1. Planning Board Meeting Materials 2026-01-05

**AGENDA**  
**York Planning Board Meeting**  
**January 5, 2026**  
**7:00 PM**  
**York Public Library**

**TO:** The York Planning Board  
**FROM:** Brendan J. H. Summerville, Town Planner  
**DATE:** 5 January 2026  
**RE:** Sketch Plan Application Review – 60 Main Street  
Map/Lot 0020-0001-A

**TO:** Planning Board  
**FROM:** Brendan J. H. Summerville, Town Planner  
**DATE:** 5 January 2026  
**RE:** Sketch Plan Application Review – 985 & 995 US Route 1  
Map 94 Lot 75A and Map 30A Lots 18 & 29

EXISTING CONDITIONS PLAN

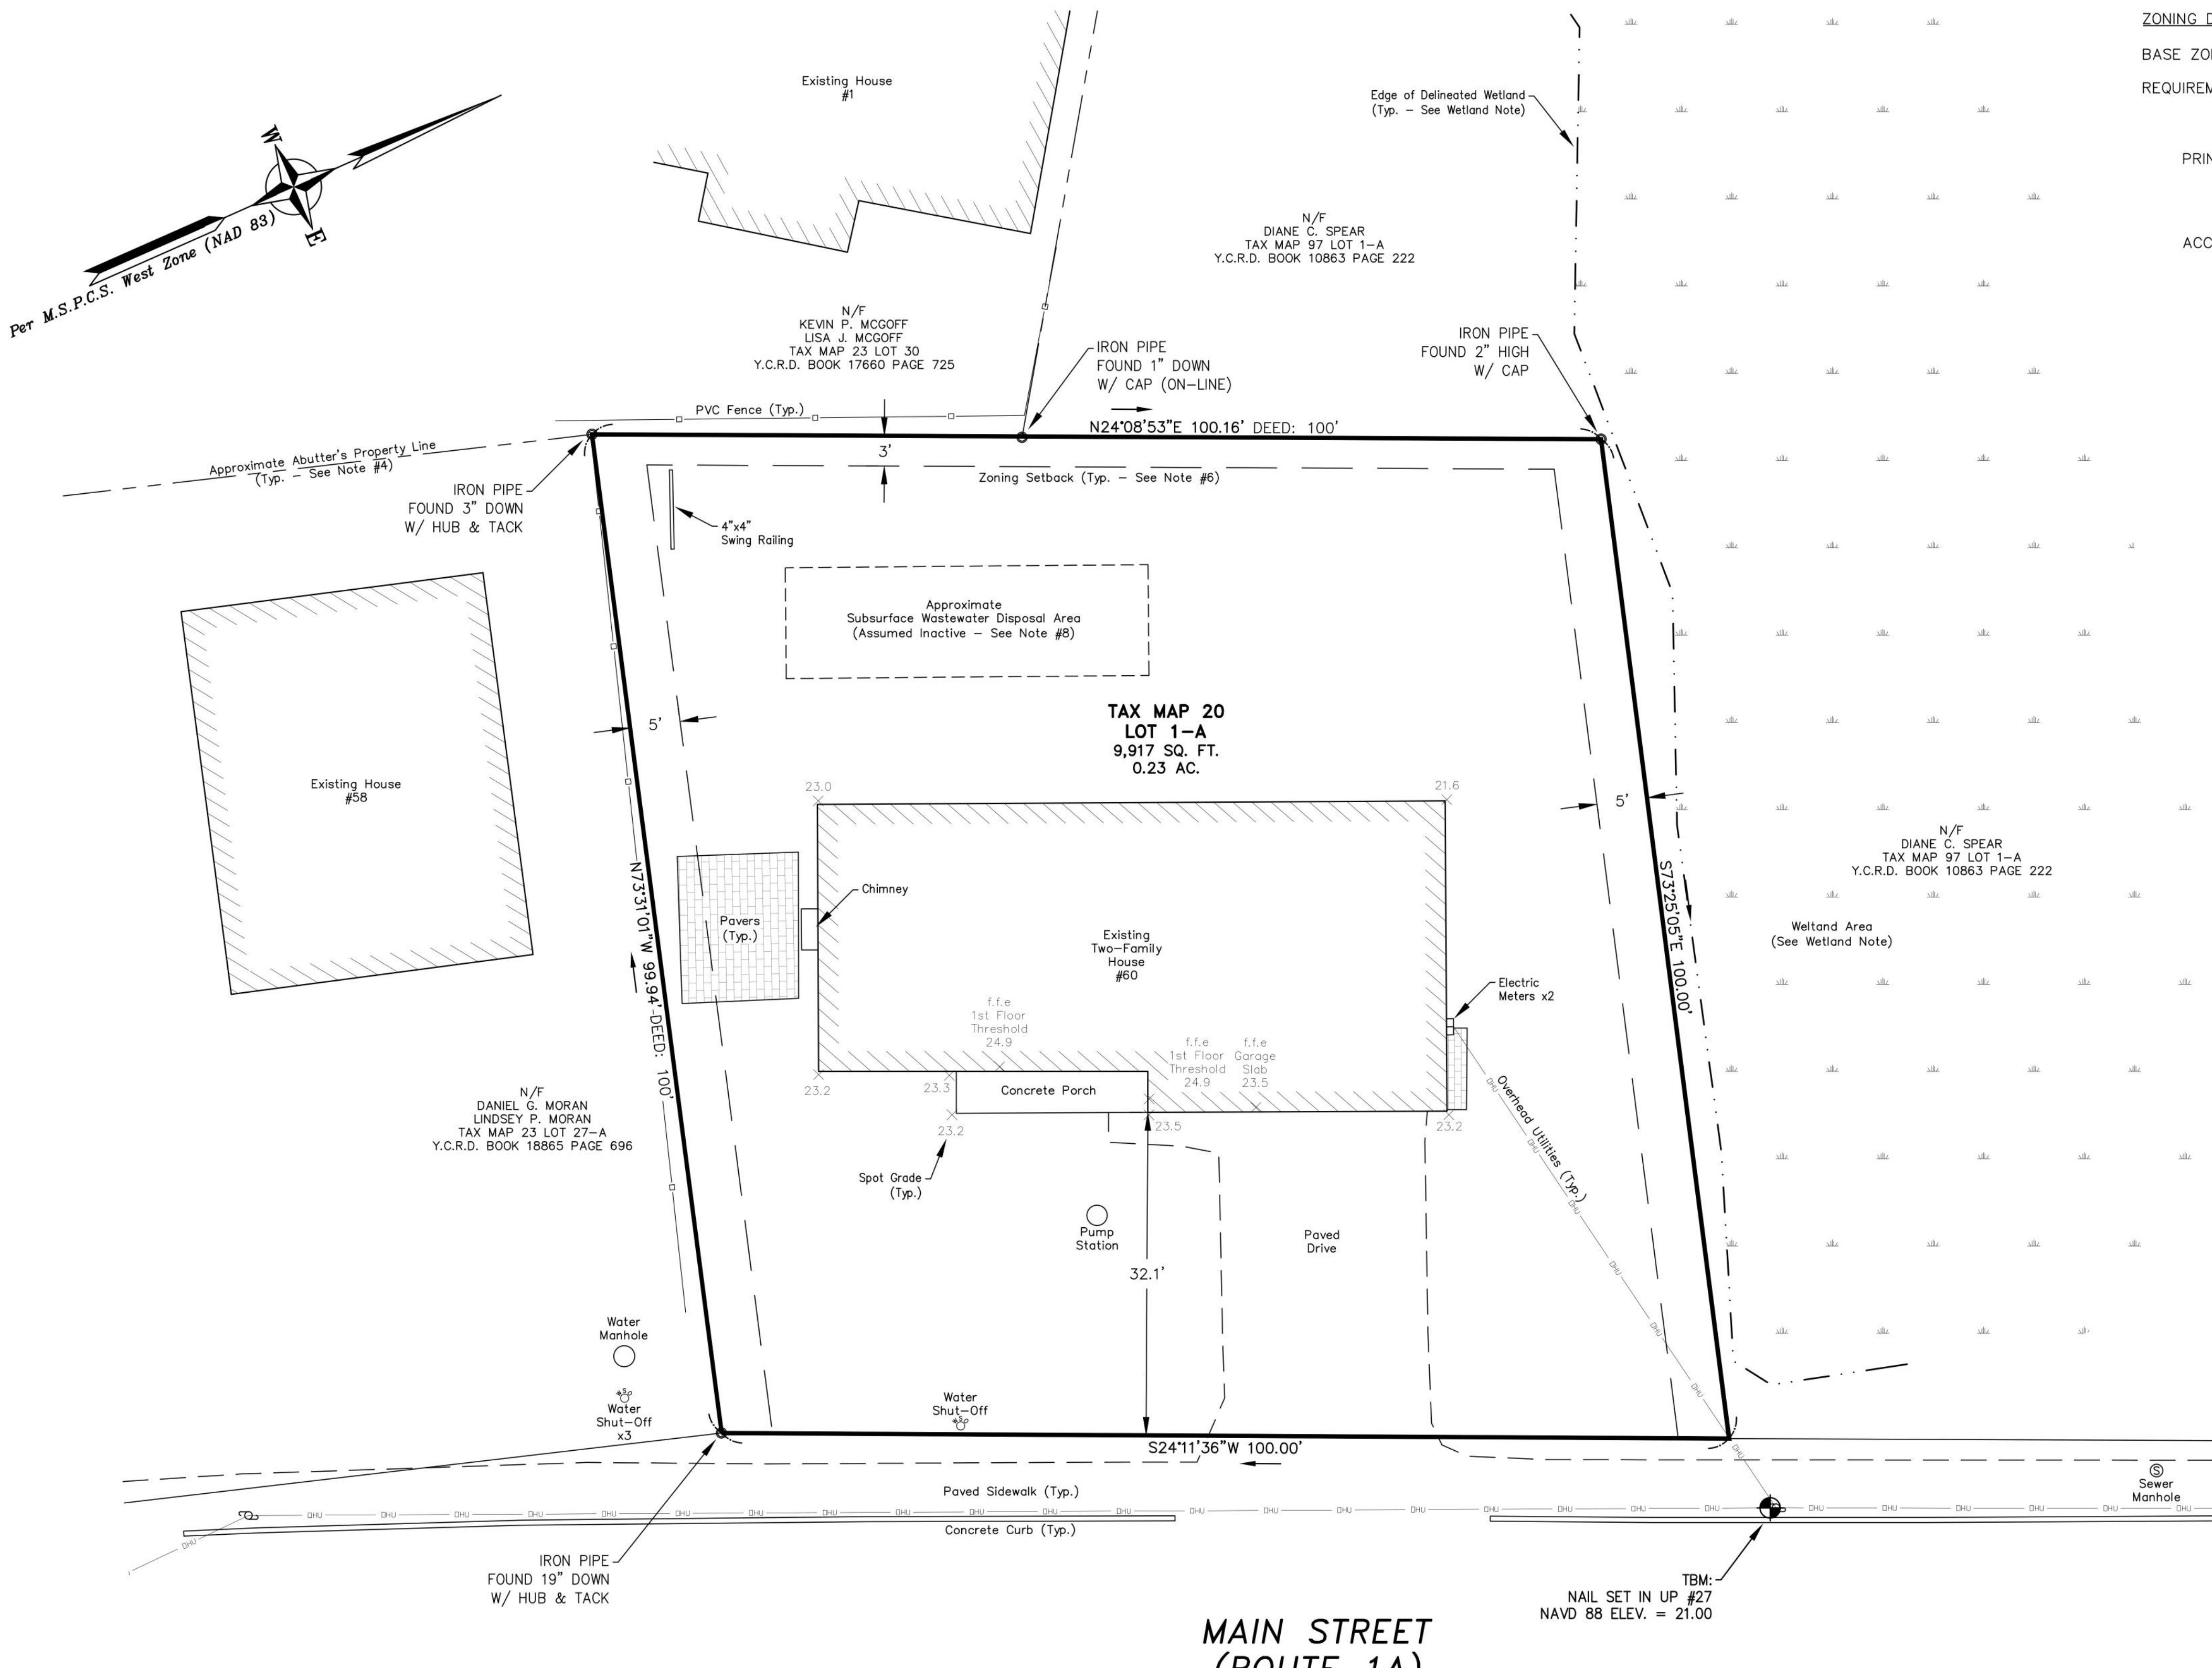
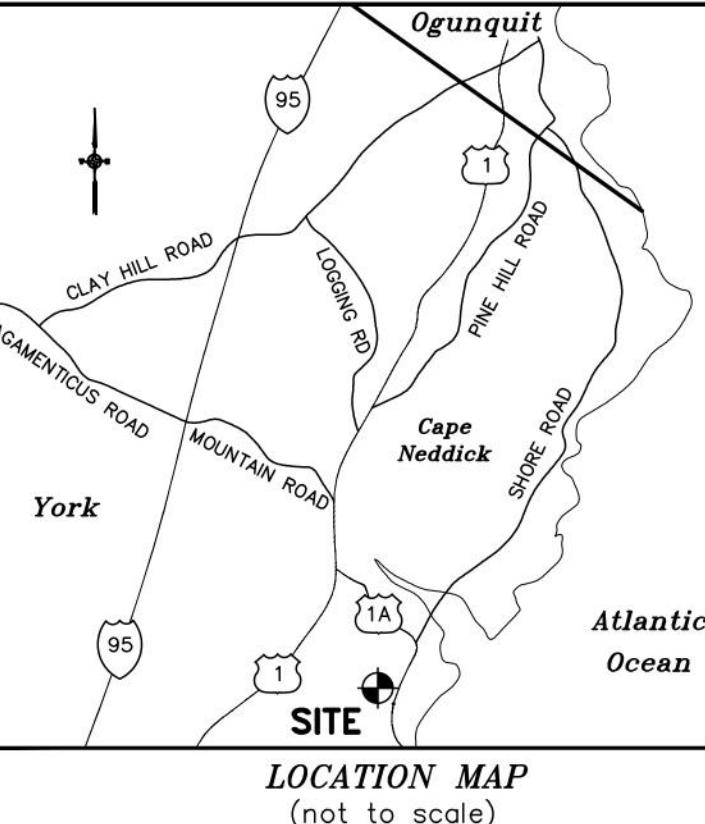
- A. Dimensional Regulations** – This property conforms to the CD-4 dimensional regulations, as presented in §10-I.4.2.1 with one exception. The CD-4 zone has a maximum front setback of 20ft, and the existing conditions plan depict a distance of 32.1ft from the road. Per §10-I.2.3.1 *General*, this development is not-exempt from these dimensional standards, even as a redevelopment of the existing structure. Were the front façade moved or extended to be within 20ft of the front property line, then this would be rendered moot.

- b) **Wetland & Shoreland Resources:** There are neither wetlands nor shoreland zones located on this site, with the wetland boundary being delineated in December of 2024 (see Existing Conditions Plan). While off site, staff recommend the applicant do their due diligence in ensuring that the wetland will not be negatively impacted by an increase in lot coverage, or through illicit discharges & filling during construction.

Exhibit 1 Plan Sheet 1

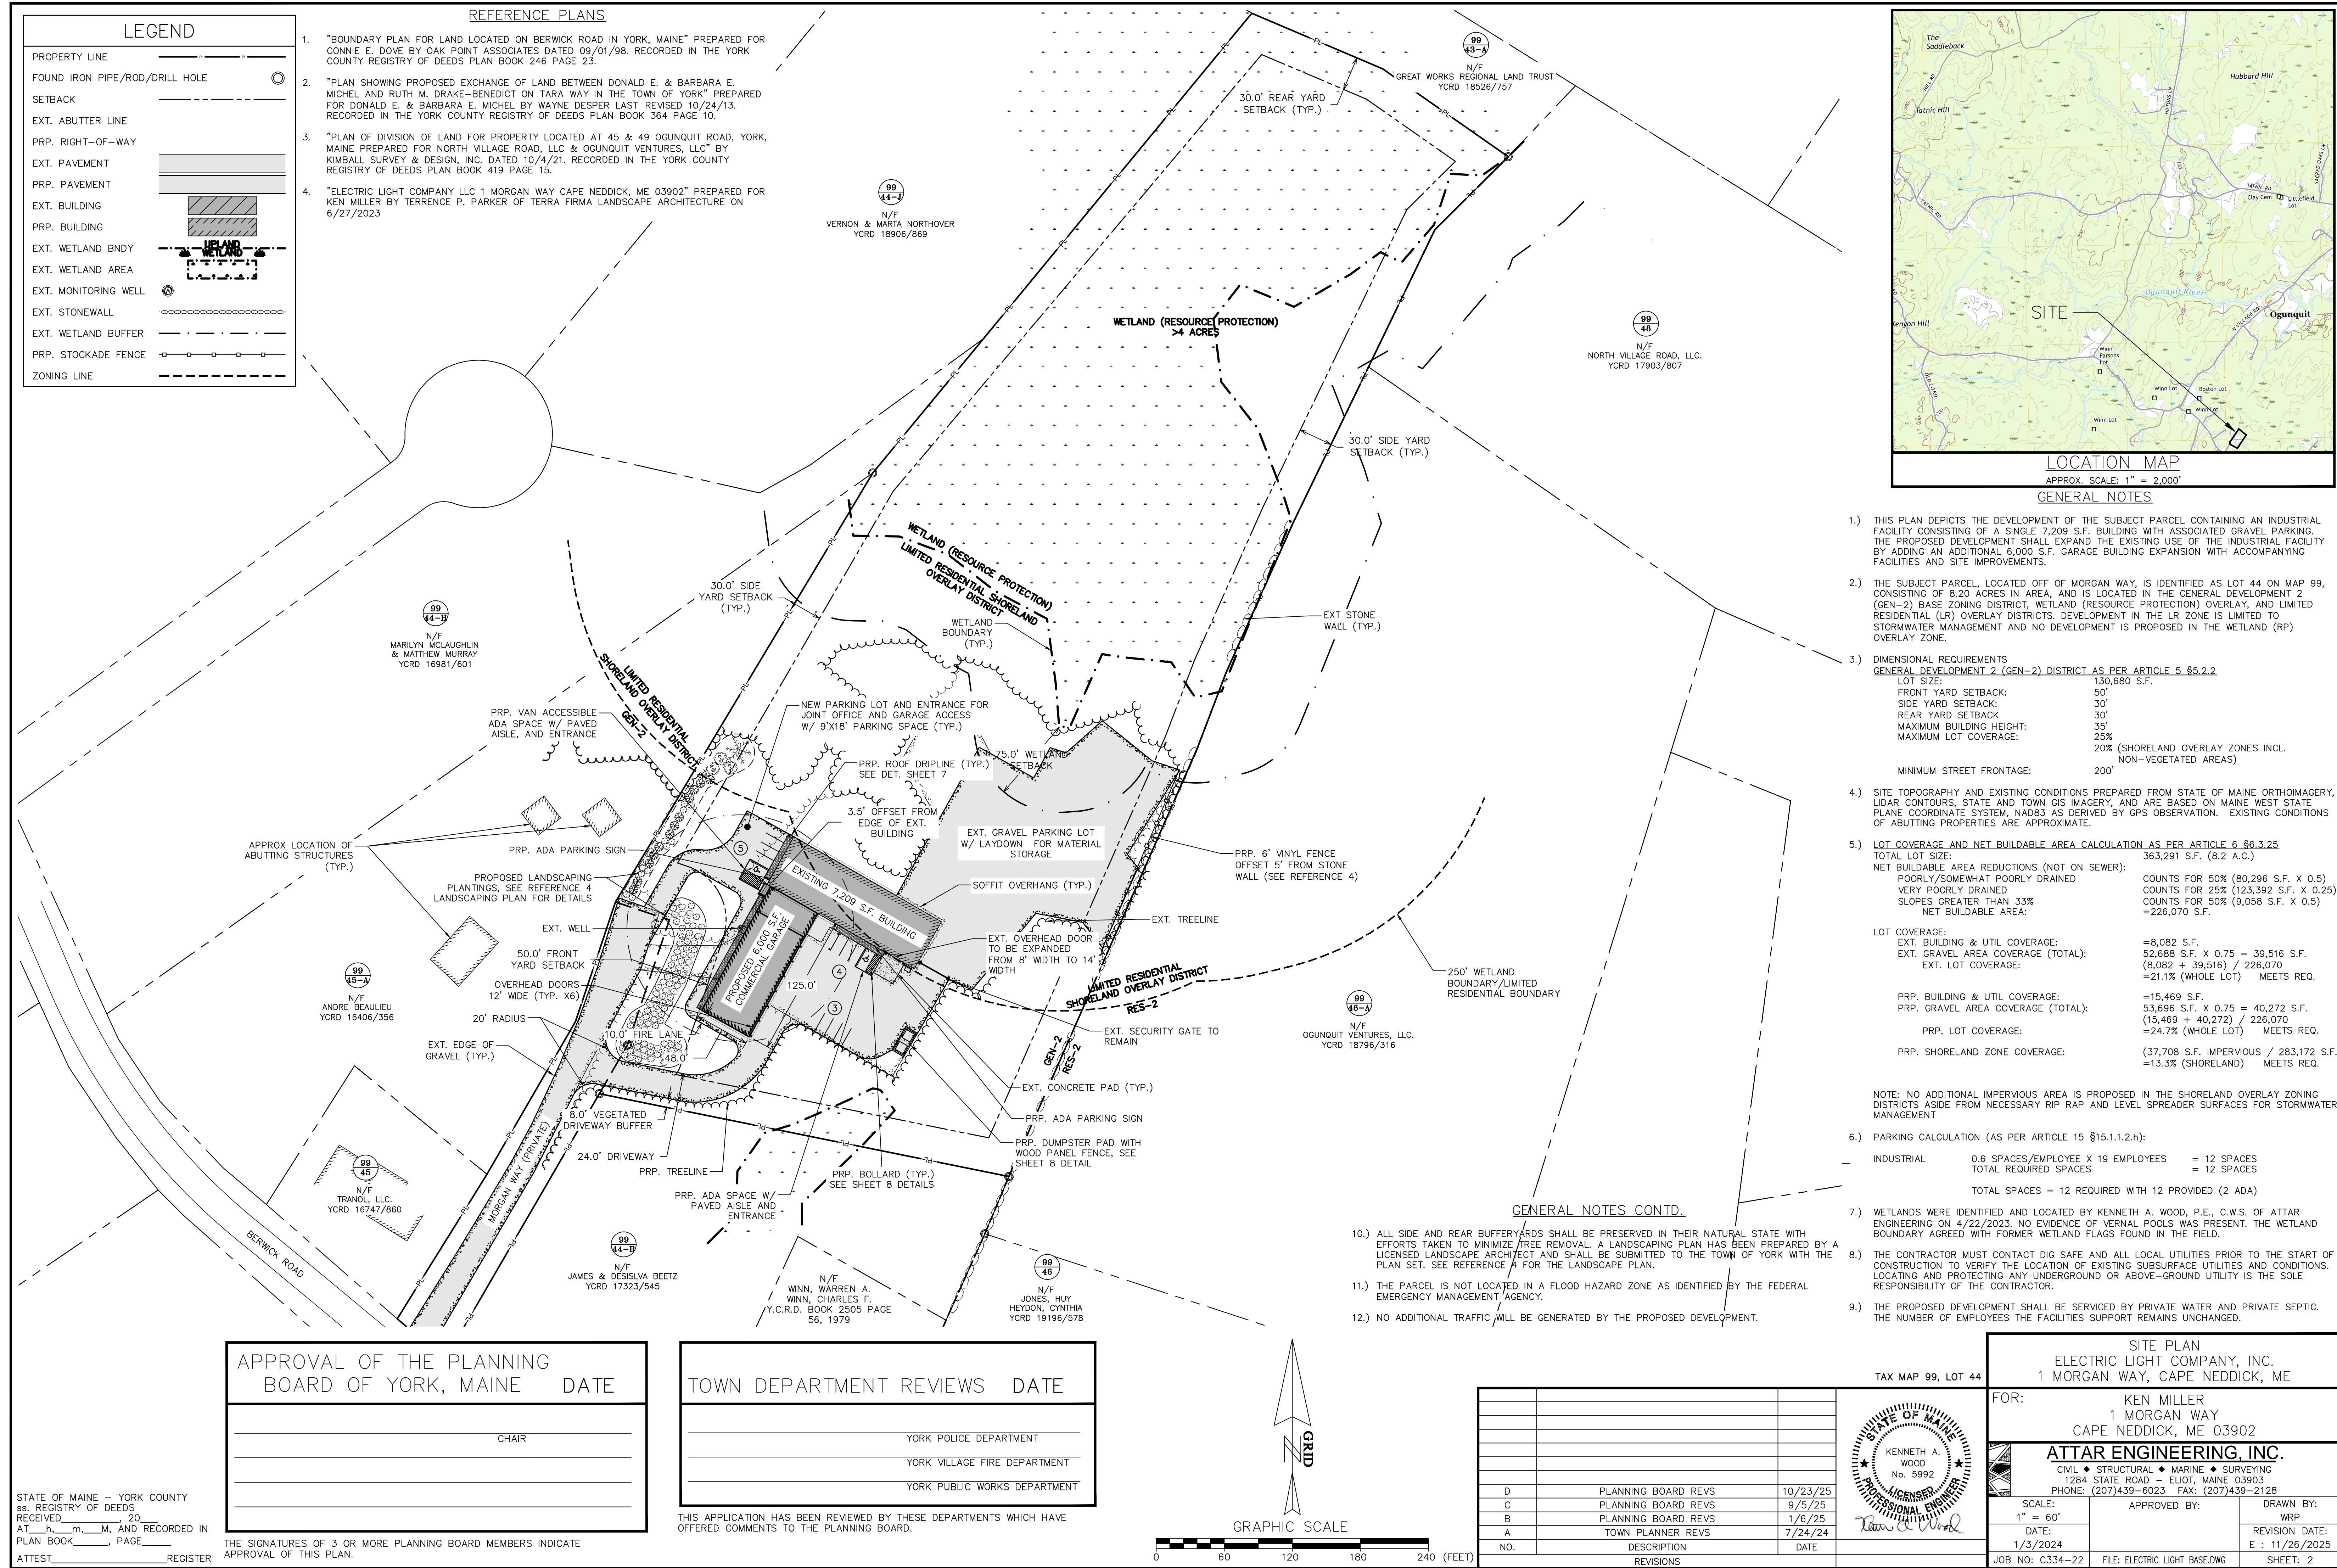
6. Demonstration of total impervious surface ratio and coverage is not entirely clear and needs further clarity and information. **The plans have been revised. The additional calculations, however, (Plan Note 5 on sheet 2) are not clear. (see comment 2.b below)**

b. In the GEN-2 zone there is a requirement not to exceed 25% impervious surface ratio for the lot. [and 20% for the area within the Shoreland Overlay Zone subdistrict Limited Residential per Article 8]. The plans (Sheet 2, Site Plan) appear to only include the buildings in the coverage calculations. See the Definitions section of the Zoning Ordinance for more information on calculating 'Impervious Surface Ratio'. The applicant has revised the plan, however, the calculations, (Plan Note 5 on sheet 2) reflect only gravel area for coverage (under 'PRP. SHORELAND..') and the note below states 'no additional impervious area' in the shoreland zone. The plans reflect approximately half the existing building within the shoreland zone, but the area doesn't appear to be reflected in the shoreland calculations. The riprap associated with the stormwater pond should be reflected in the total coverage amounts. The Applicant should confirm and revise accordingly.
